Jeri Scott - FW: RCEC - Responses from PG&E to Follow-up Transmission Questions

From: Jim McLucas [mailto:jmclucas@calpine.com]
Sent: February 02, 2007 10:15 AM
To: Ajoy Guha (CEC)
Cc: Michael Hatfield; Davy, Doug/SAC; Gregg Wheatland (glw@eslawfirm.com); Alan Roth
Subject: RCEC - Responses from PG&E to Follow-up Transmission Questions

The following information addresses the CEC staff's additional questions which you conveyed to us.

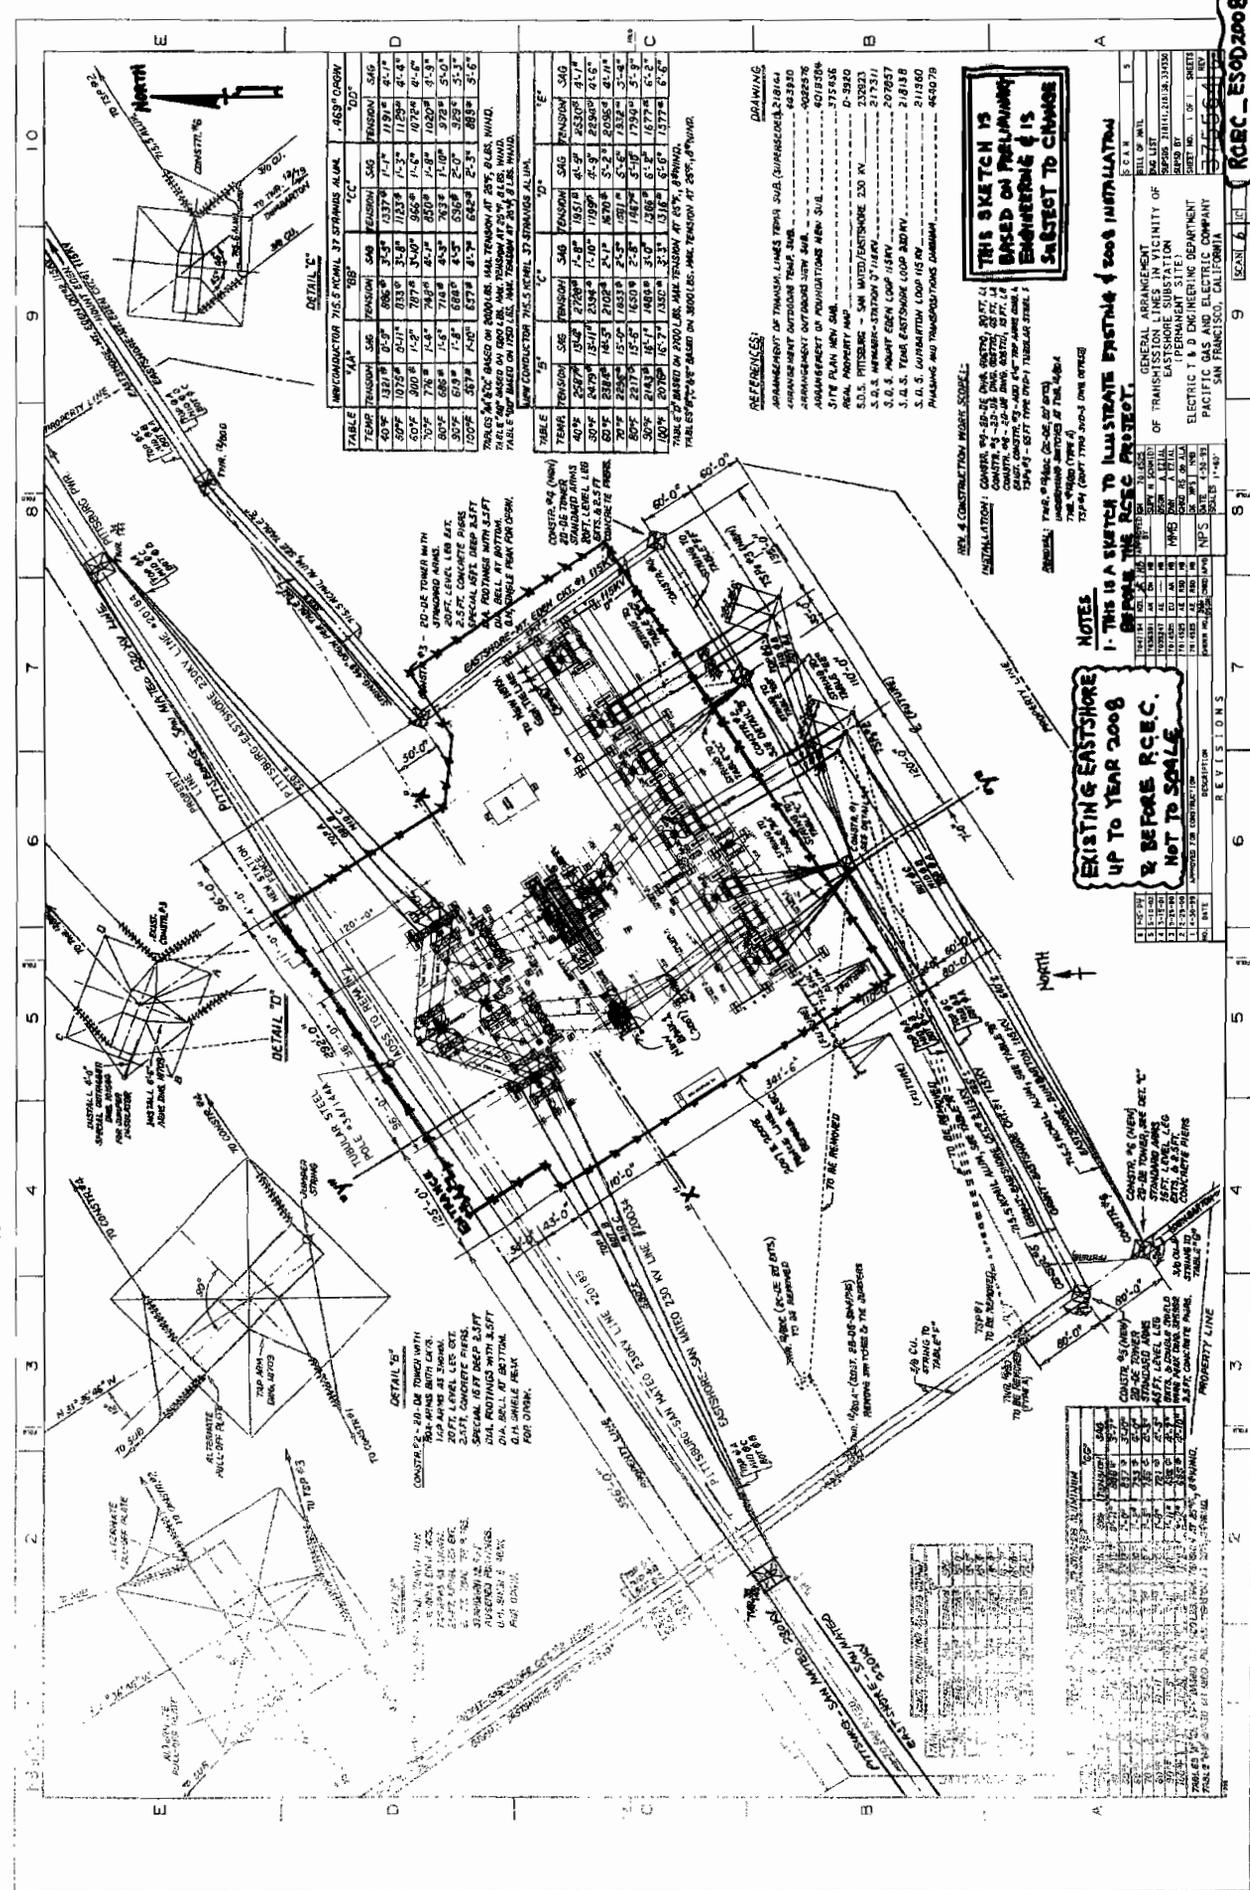
Sketches RCEC_ESOD2008 and RCEC_ESOD2009, based on preliminary engineering and subject to change, are attached. Sketch RCEC_ESOD2008 shows the existing Eastshore Substation plus the replacement of the 230/115 kV Transformer No. 1 with one three-phase 420 MVA bank, under the PG&E Project No. P.01951, and the installation of one new 115 kV breaker position in 2008 for P0413 generation project. This sketch shows Eastshore Substation before the RCEC project. Sketch RCEC_ESOD2009 conceptually shows Eastshore Substation after the RCEC project. This sketch shows the approximate location of the fence line for the expanded substation. A detailed general arrangement drawing is not available at this time. However, we can confirm that our work to date shows that there is sufficient physical space available for the RCEC equipment. The existing 230 kV portion of the substation, which will be expanded to accommodate the interconnection of RCEC, is on the north side of the substation. The 230 kV portion of the substation will be expanded to the west.

SKETCH # CYLO13007
SINGLE LINE DIAGRAM (SIMPLIFIED)
EASTSHORE SUBSTATION
RUSSELL CITY ENERGY CENTER PROJECT

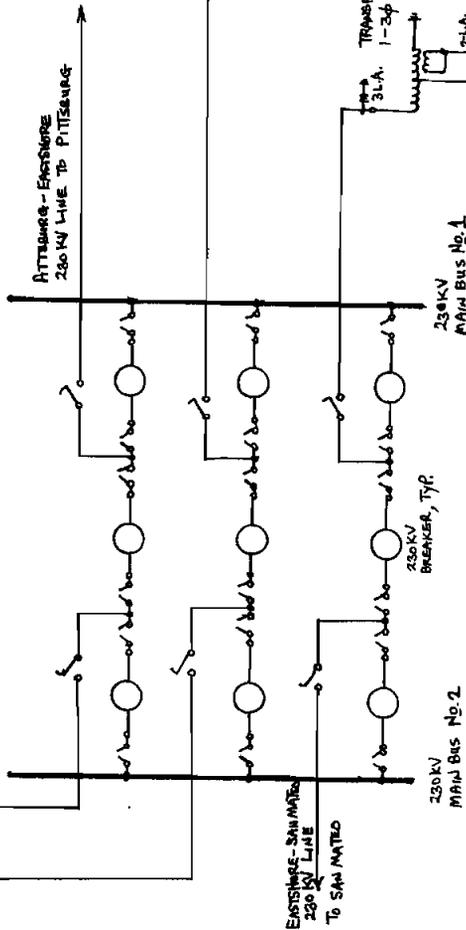
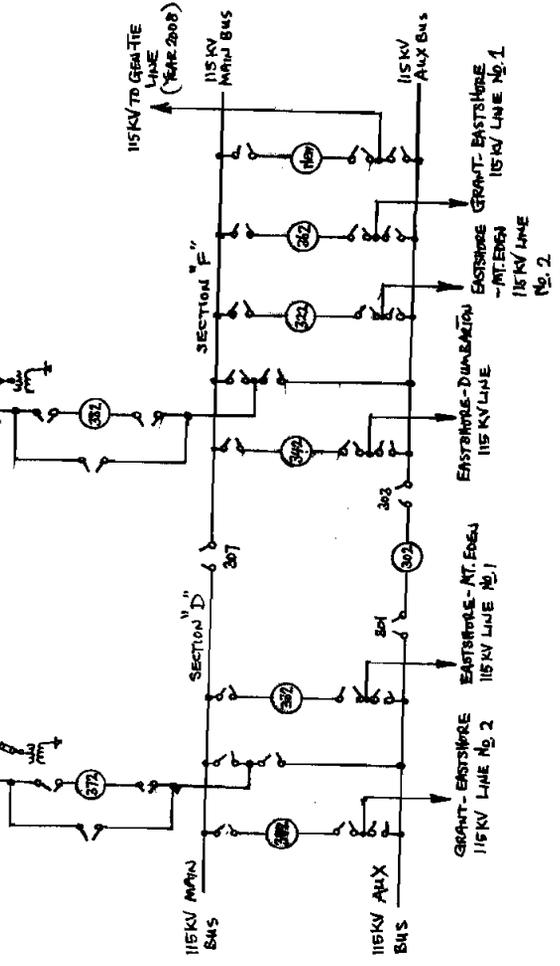
- Data Requests 45: A one line diagram for Eastshore Substation may be found on page 2 of the November 2, 2006 Interconnection Facilities Study Report (Re-Study). Sketch Eastshore_SL2009, based on preliminary engineering and subject to change, is attached. It shows the electrical single line of Eastshore Substation for and after the RCEC project. The equipment ratings, as currently planned, are as follows:
 - 230 kV bus: 3000 ACC for Main Bus 1 and Bus 2. 2000 ACC for each BAAH (breaker-and-a-half) bay
 - 230 kV circuit breakers: 2000 ACC, 40kA IC
 - 230 kV disconnect switches: 2000 ACC
 - 115kV/230kV transformers: 3-phase, autotransformer, 252/336/420 MVA, ONAN/ONAF/ONAF, HV 230/120kV Ground-Y, TV 13.2kV Grounded-Delta

GENERAL ARRANGEMENT OF TRANSMISSION LINE TOWER AT EASTSHORE SUBSTATION (PERMANENT SITE)
 ELECTRIC T & D ENGINEERING DEPARTMENT
 PACIFIC GAS AND ELECTRIC COMPANY
 SAN FRANCISCO, CALIFORNIA

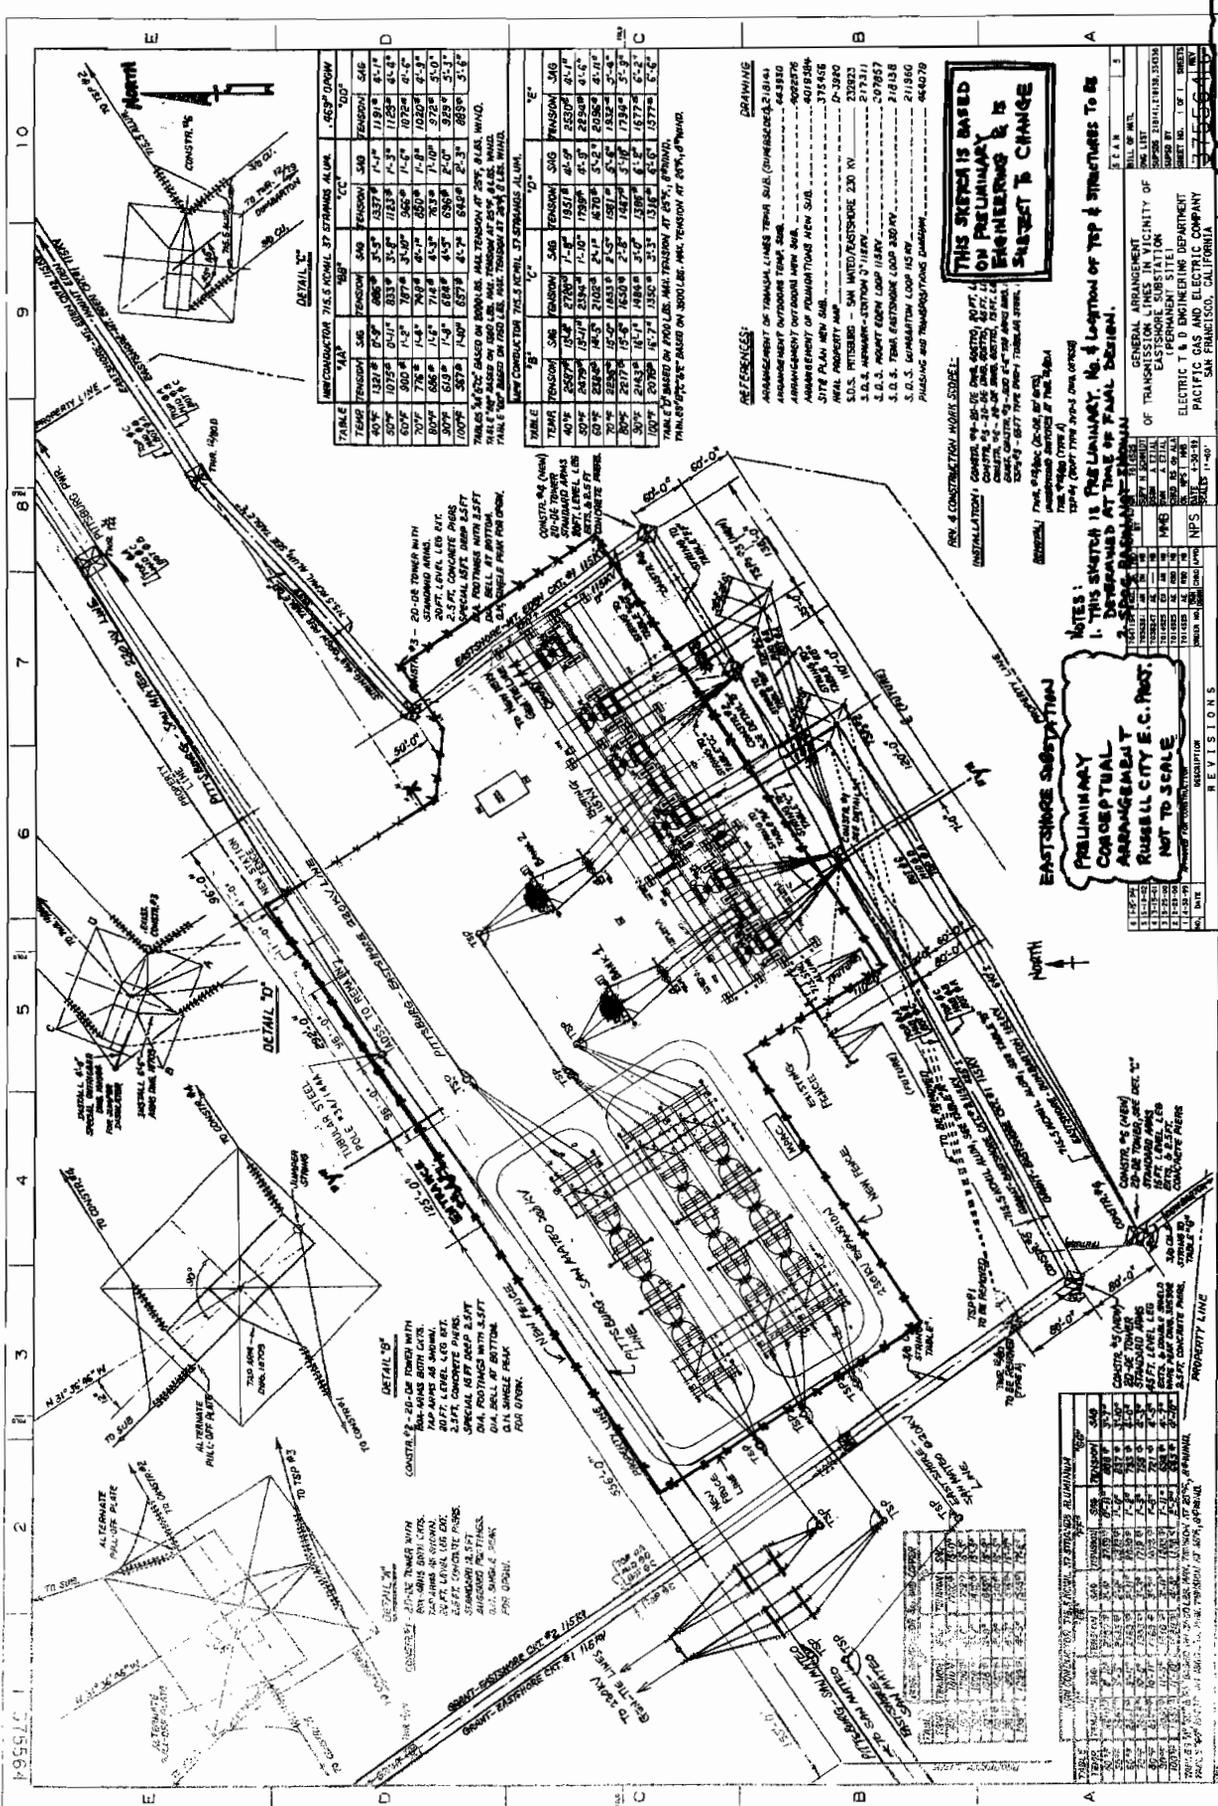
Sketches RCEC_ESOD2008 and RCEC_ESOD2009, based on preliminary engineering and subject to change, are attached. Sketch RCEC_ESOD2008 shows the existing Eastshore Substation plus the replacement of the 230/115 kV Transformer No. 1 with one three-phase 420 MVA bank, under the PG&E Project No. P.01951, and the installation of one new 115 kV breaker position in 2008 for P0413 generation project. This sketch shows Eastshore Substation before the RCEC project. Sketch RCEC_ESOD2009 conceptually shows Eastshore Substation after the RCEC project. This sketch shows the approximate location of the fence line for the expanded substation. A detailed general arrangement drawing is not available at this time. However, we can confirm that our work to date shows that there is sufficient physical space available for the RCEC equipment. The existing 230 kV portion of the substation, which will be expanded to accommodate the interconnection of RCEC, is on the north side of the substation. The 230 kV portion of the substation will be expanded to the west.

SKETCH # CYLD13007
SINGLE LINE DIAGRAM (SIMPLIFIED)
EASTSHORE SUBSTATION
RUSSELL CITY ENERGY CENTER PROJECT

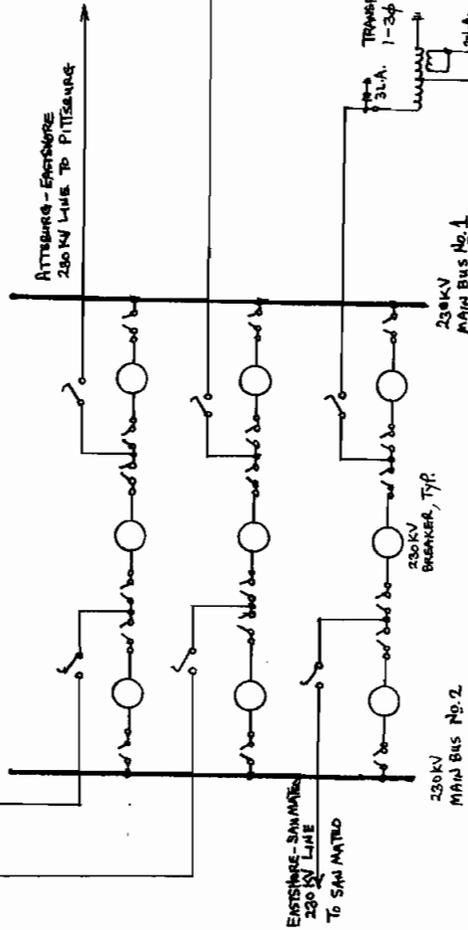
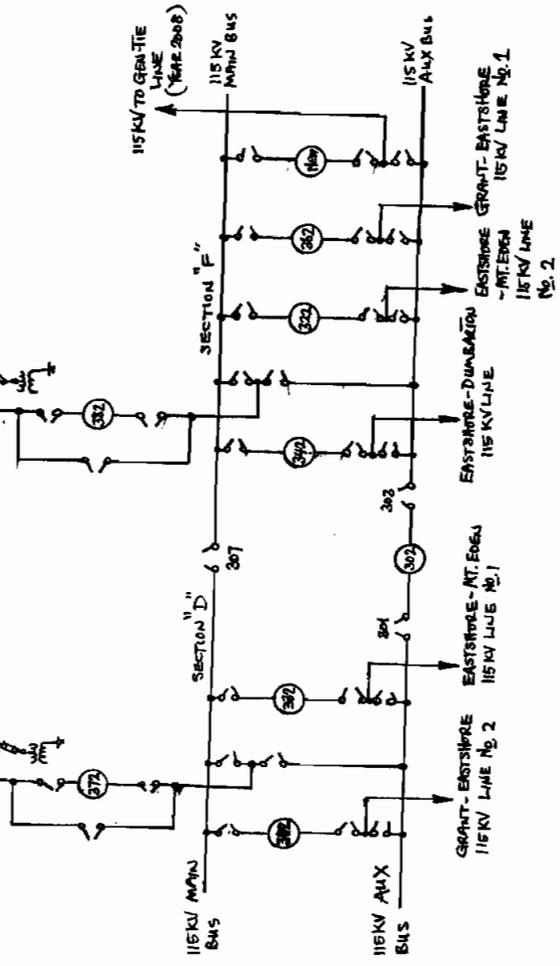
- Data Requests 45: A one line diagram for Eastshore Substation may be found on page 2 of the November 2, 2006 Interconnection Facilities Study Report (Re-Study). Sketch Eastshore_SL2009, based on preliminary engineering and subject to change, is attached. It shows the electrical single line of Eastshore Substation for and after the RCEC project. The equipment ratings, as currently planned, are as follows:
 - 230 kV bus: 3000 ACC for Main Bus 1 and Bus 2. 2000 ACC for each BAAH (breaker-and-a-half) bay
 - 230 kV circuit breakers: 2000 ACC, 40kA IC
 - 230 kV disconnect switches: 2000 ACC
 - 115kV/230kV transformers: 3-phase, autotransformer, 252/336/420 MVA, ONAN/ONAF/ONAF, HV 230/120kV Ground-Y, TV 13.2kV Grounded-Delta
